Visual Resource Management Plan

FERC Project No. 184
El Dorado Irrigation District

El Dorado Hydroelectric Project (FERC No. 184)
El Dorado Irrigation District
Placerville, CA

Table A-3. Forest Service Comments on the Revised Draft VRMP and Applicable Revisions.

Figure 2.1-1. El Dorado Hydroelectric Project Area and Facilities

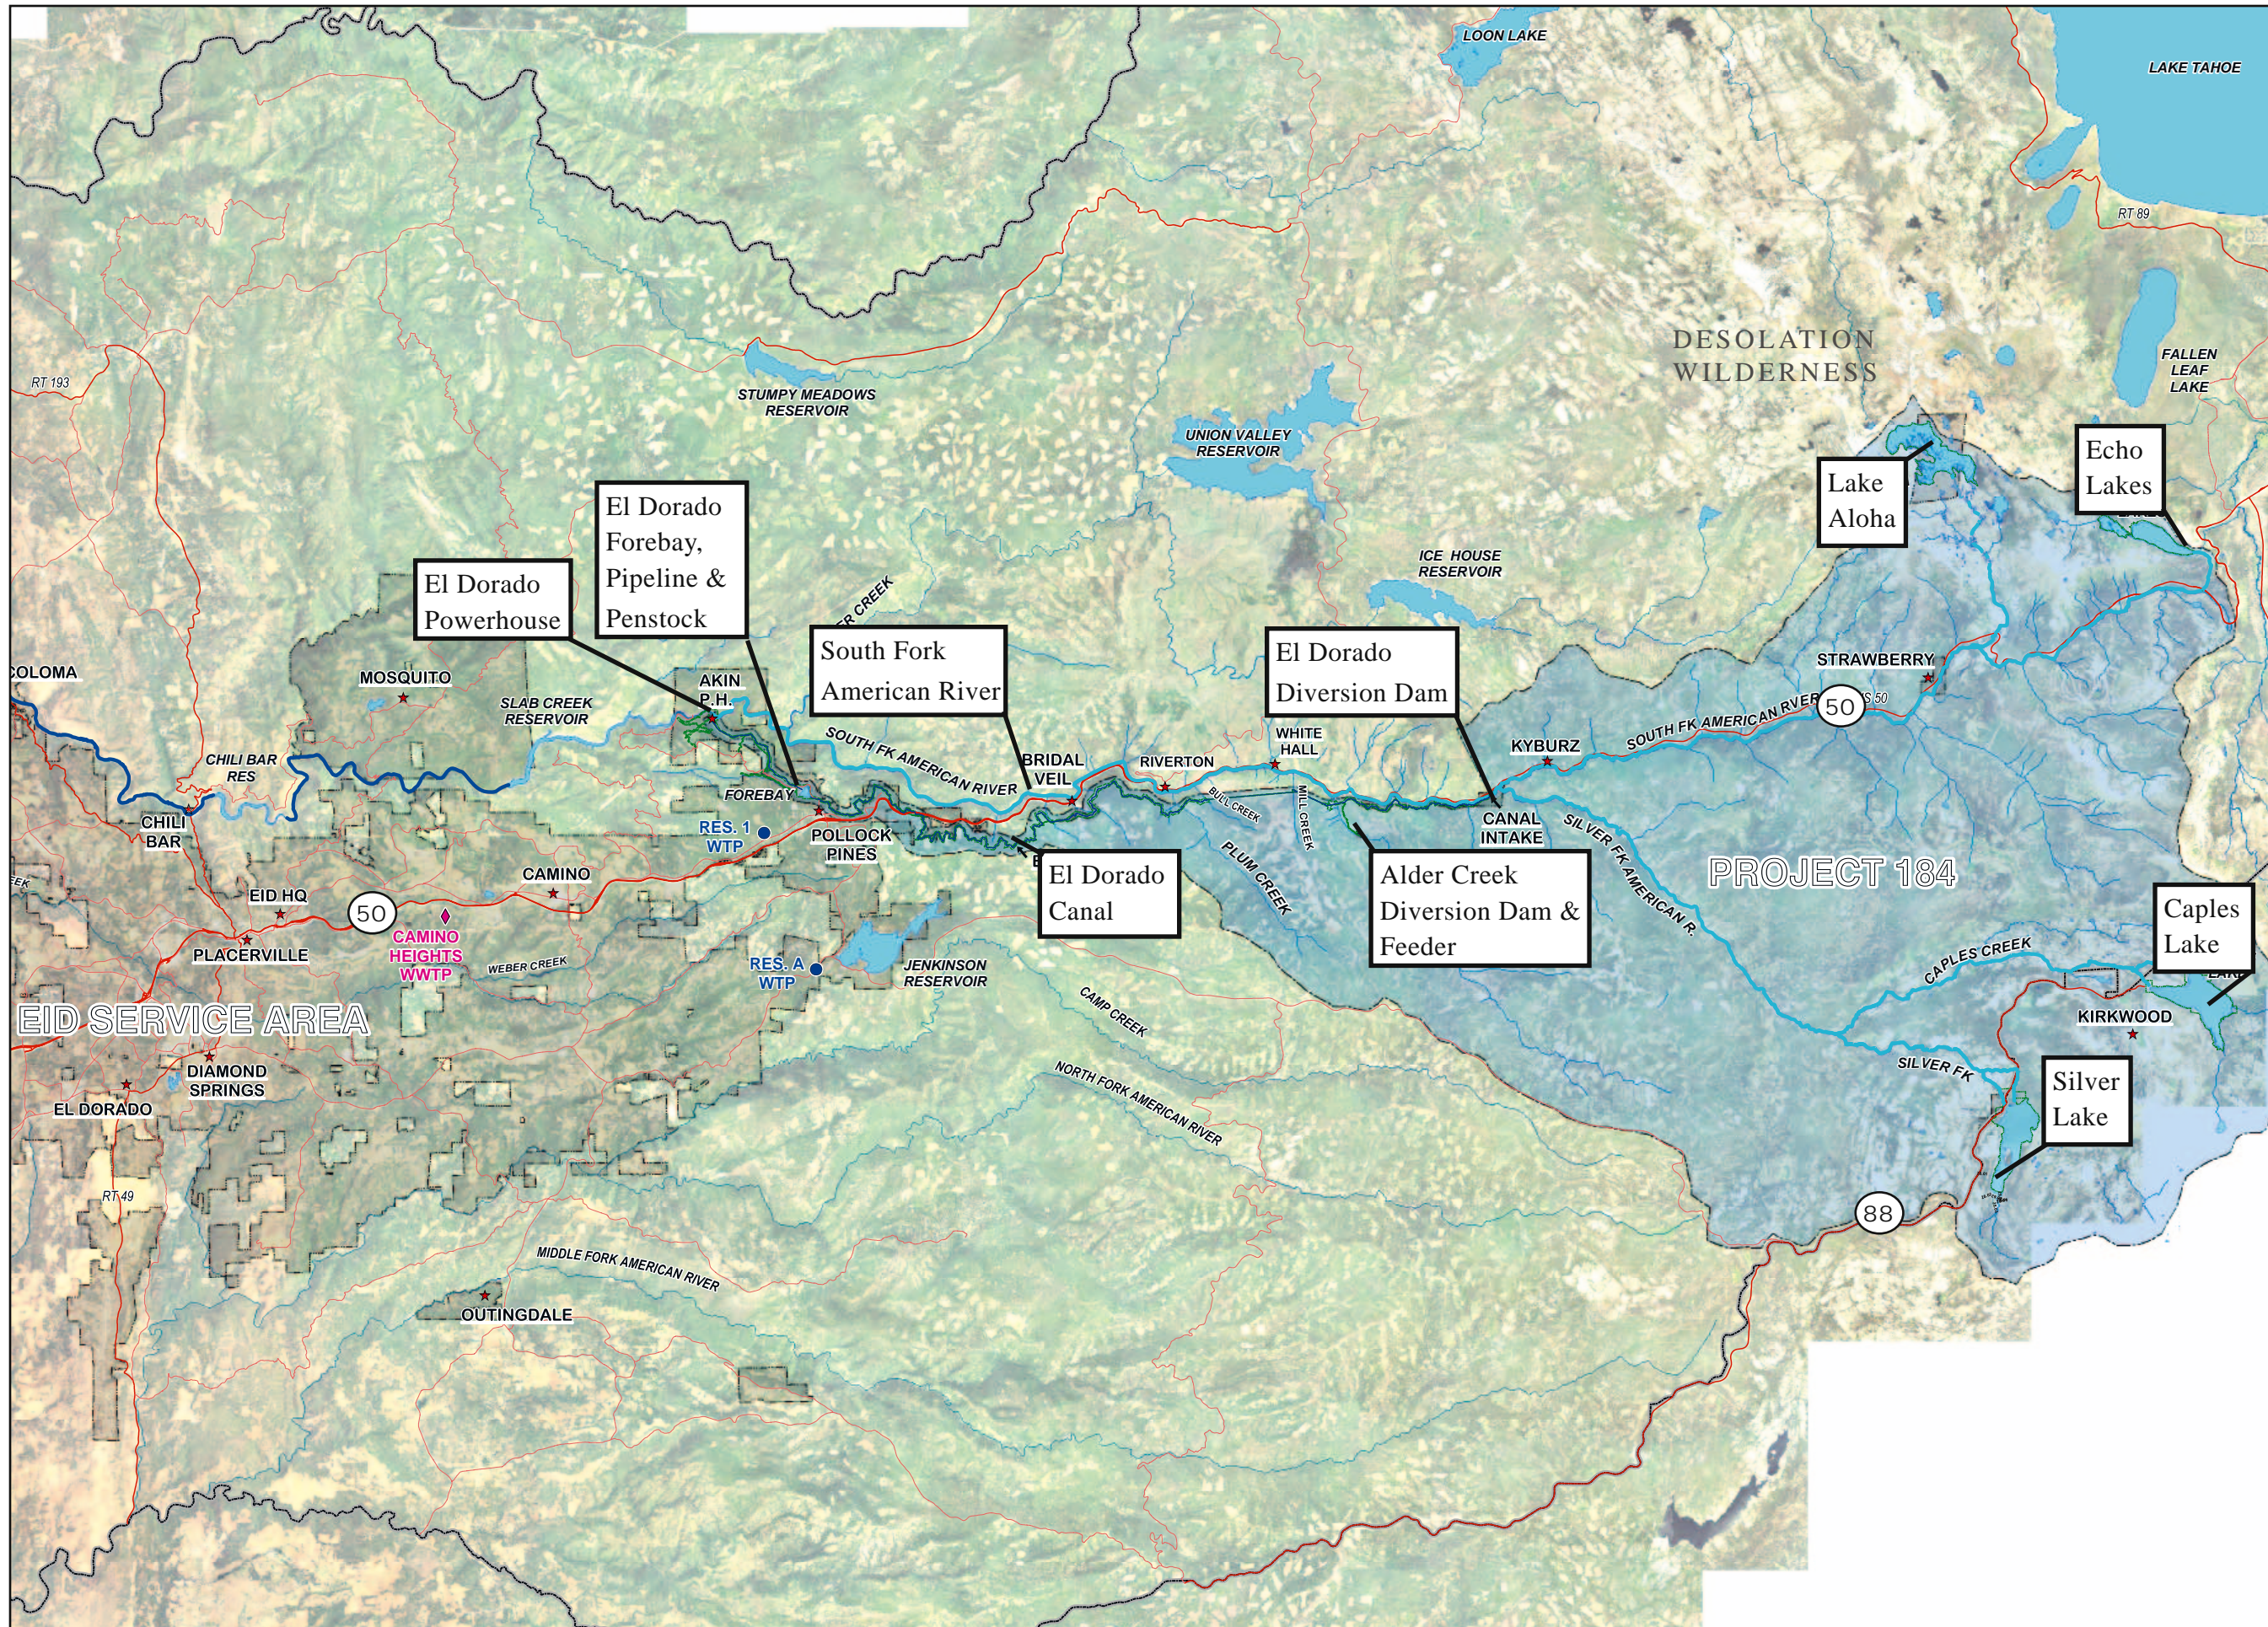
FS Comment	Plan Revision
Pg. 7 is missing.	Pagination has been fixed. Page 7 is figure 2.1-1.
Pg. 9, para. 1, sentence 2: SH 88 is a state scenic highway not a state scenic byway. This is an error throughout the document. It is a national forest scenic byway.	This correction has been made through the plan.
Pg. 9, para. 1, sentence 4: Add "recreation" between "developed" and "facilities".	Sentence revised to read: “...and Partial Retention for areas with developed recreation facilities.”
Pg. 9, para. 3, sentence 1: There is only one private resort/lodge on Caples Lake.	Sentence revised to read: “Recreation facilities and public areas adjacent to the lake include a private resort...”
Pg. 9, para. 4, sentence 3: The auxiliary dam and appurtenances are visible from the trail, lake and highway 88. The following sentence "however, once on the trail," should read "further down the trail".	Sentence revised to read: “However, further down the trail away from the trailhead, the dam is barely distinguishable...”
